CONTRACT CHANGE ORDER NO. ____
SHEET ___ OF ___

SAN FRANCISCO OAKLAND BAY BRIDGE
EAST SPAN SEISMIC SAFETY PROJECT
SELF-ANCHORED SUSPENSION BRIDGE
(SUPERSTRUCTURE & TOWER)

GIRDER AT EAST TRANSITION NO. 16

ELEVATION - LONGITUDINAL SHEAR PLATE TYPE 2, E3, W3 LINE ONLY (PP120 TO PP127)

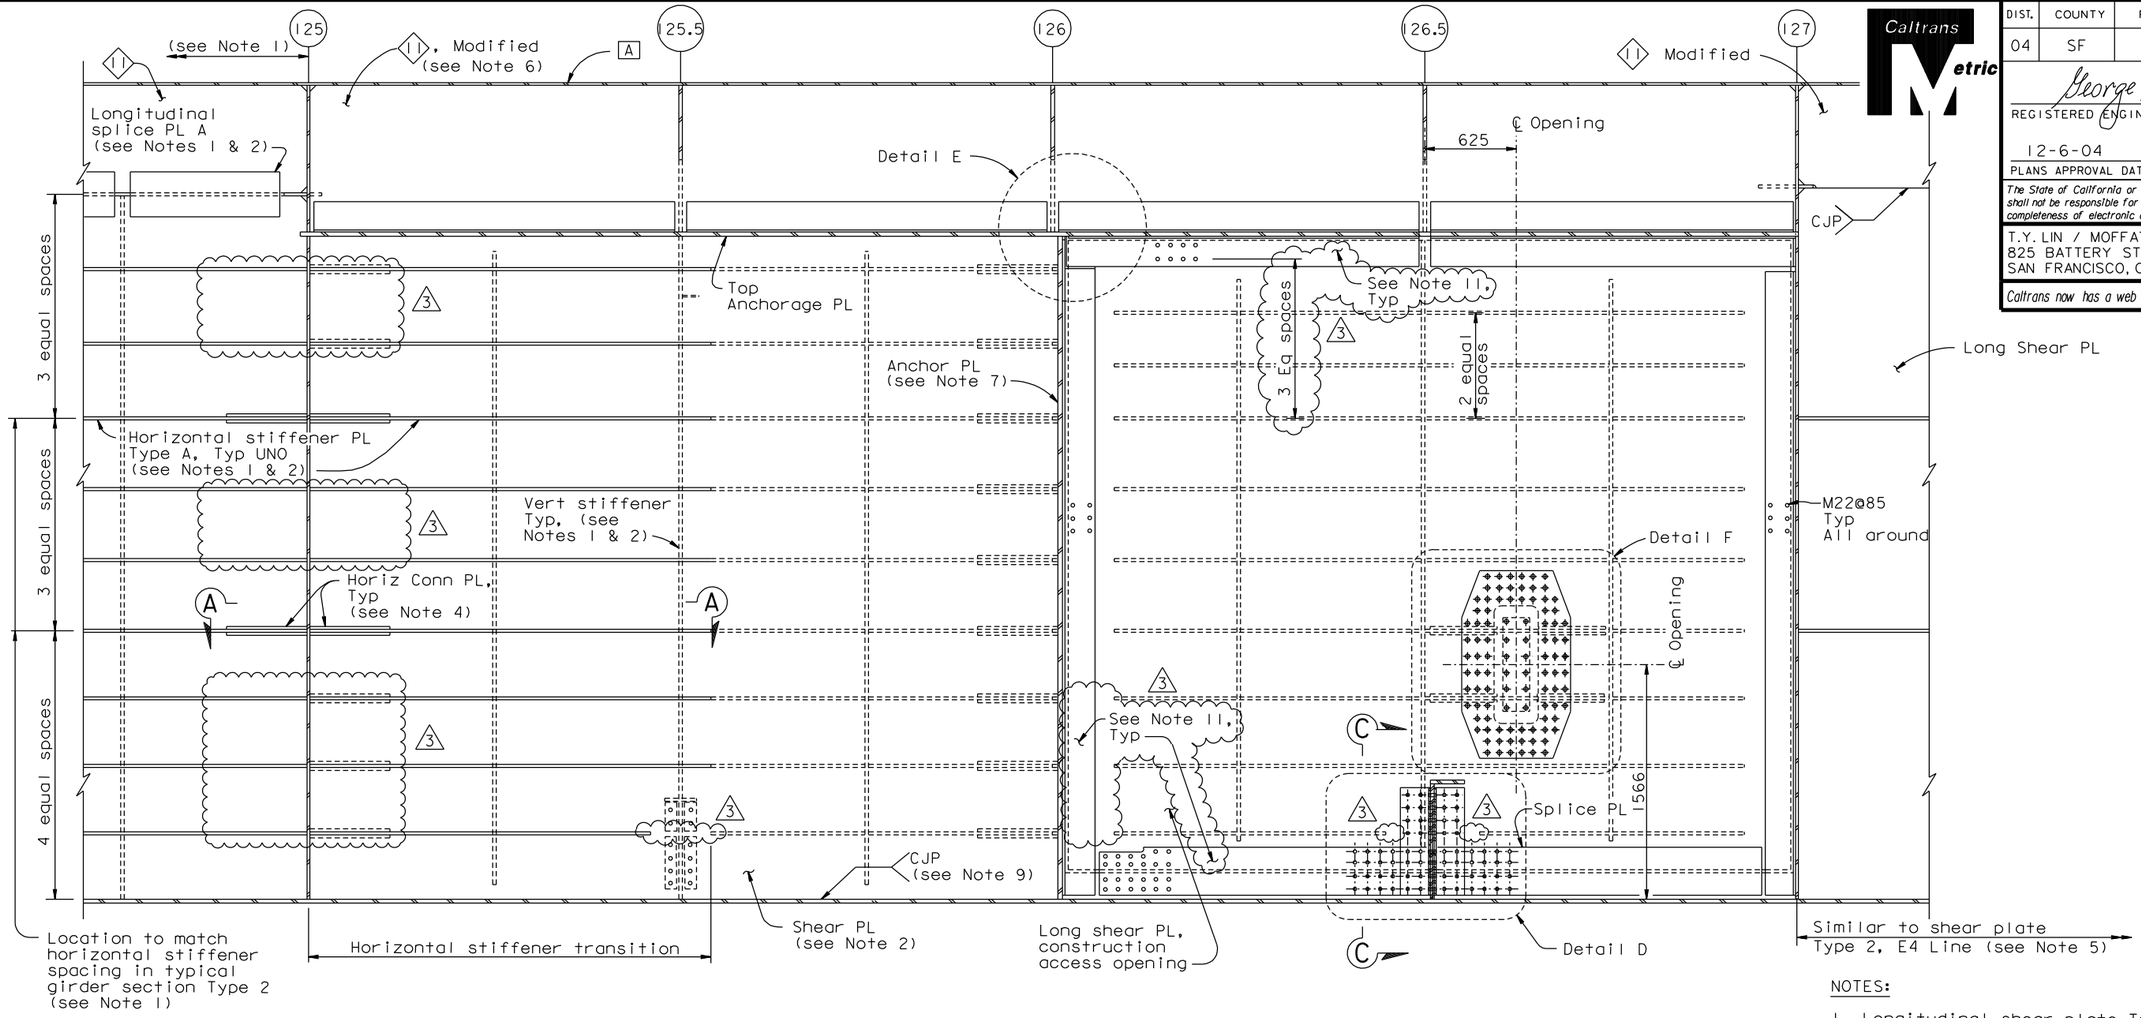
MARK	DATE	DESCRIPTIONS	BY	CH'D	CCO#
3	09/01/11	EAST END OBG	DT	GB	87
2	06/10/11	ADDITIONAL ACCESS AT EAST END	DT	MN	202
1	07/31/09	LONGITUDINAL SHEAR PLATE	DT	GB	122

10. For Detail F, see "Girder At East Transition Details No.6" sheet.
11. At the Contractor's option, the bolted splice between PP126 and PP127 may be replaced with a CJP weld, subject to review and approval of the Engineer. (3)
